FIRST REVIEW
WC³ Project #: 222-525-043
Weber County

Subject: Sundown Condominiums – Plan Review Comments 1st Review

Project Name: Sundown Condominiums

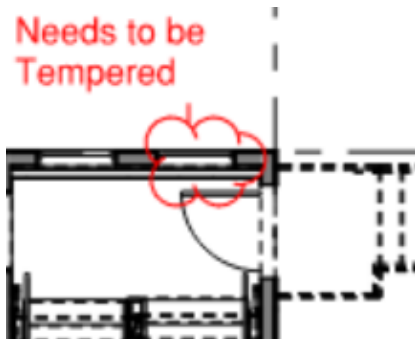
- V. The Fire Barriers around the Interior stair enclosure would also need to go from the slab to the underside of the floor above (not the ceiling) see diagram below from commentary. I don't know how you would do this with your floor framing design.
